SERVICE BULLETIN

Service Bulletin No.: DA20-79-08 Rev 1

Title: Introduction of a new Oil pressure Indicator

FUSE ASSEMBLY (20-7931-00-00)

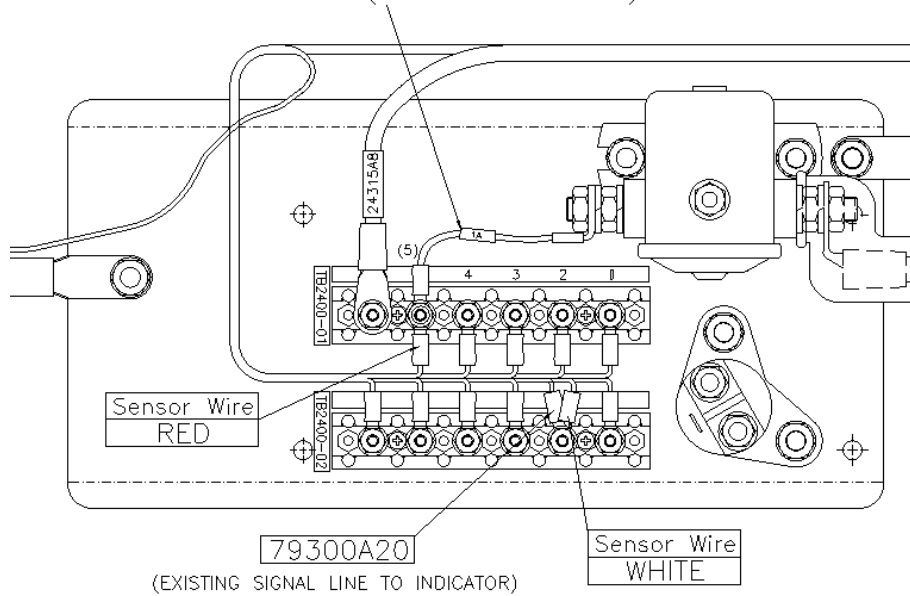
10.2.3 Connect new Oil Pressure Sensor wires to electrical shelf as shown below. Cap and stow BLACK.

10.2.4 Install Fuse Assembly (p/n 20-7931-00-00) from battery relay to terminal block post #5 as shown below.

p/n 956413 Sensor Wire	Location
RED	TERMINAL POST #5 on Terminal block TB2400-01
WHITE	TERMINAL POST #2 on Terminal block TB2400-02
BLACK	CAP AND STOW

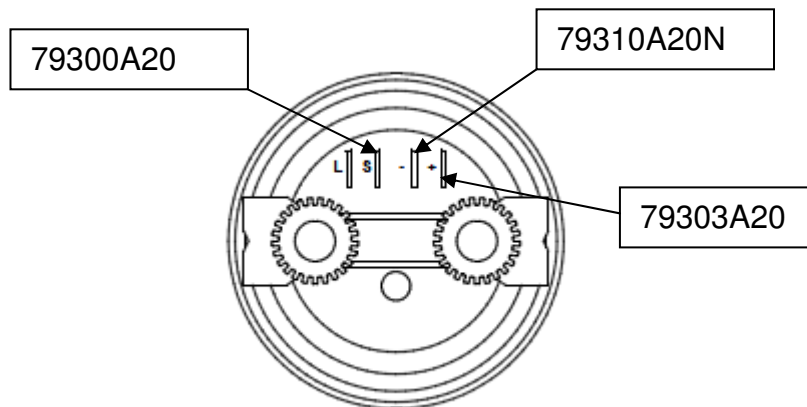
10.3.2 Remove existing Oil Pressure Indicator and replace with new Oil Pressure Indicator (p/n 20-7930-00-00).

10.3.3 Secure wires 79303A20, 79310A20N and 79300A20 to Oil Pressure Indicator as shown below.

Oil Pressure Sensor Wiring Schematic

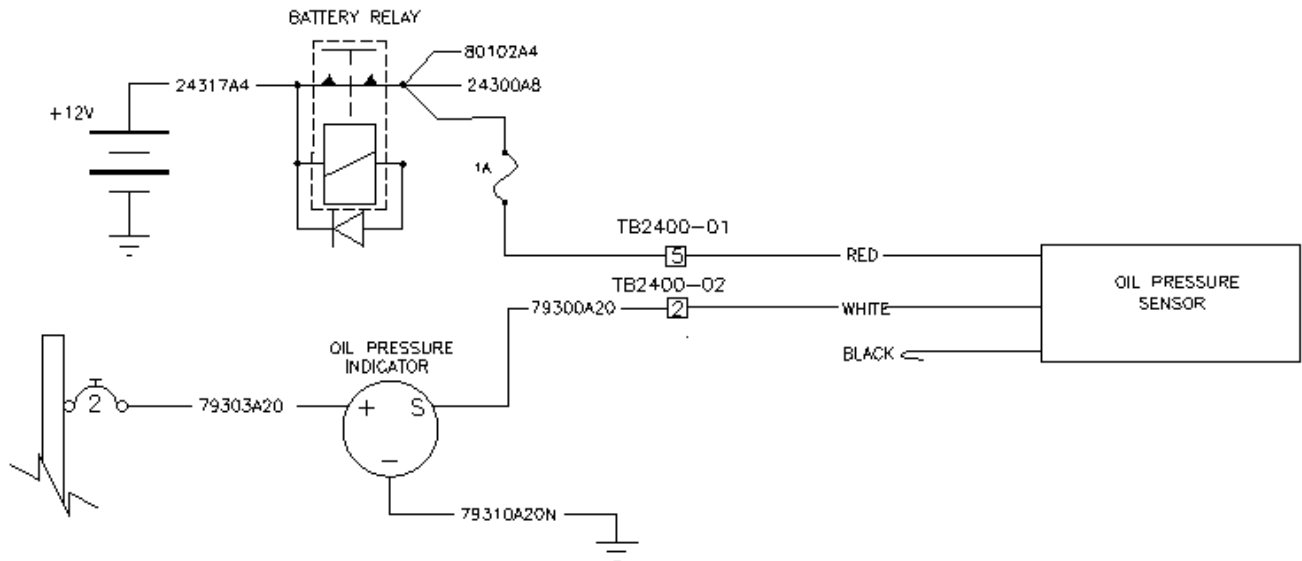
10.2.1 Route Oil Pressure Sensor pigtail in place of existing wire 79304A20 to electrical shelf located on firewall. Secure wiring using standard aircraft practices and procedures. Remove and discard existing wire 79304A20.
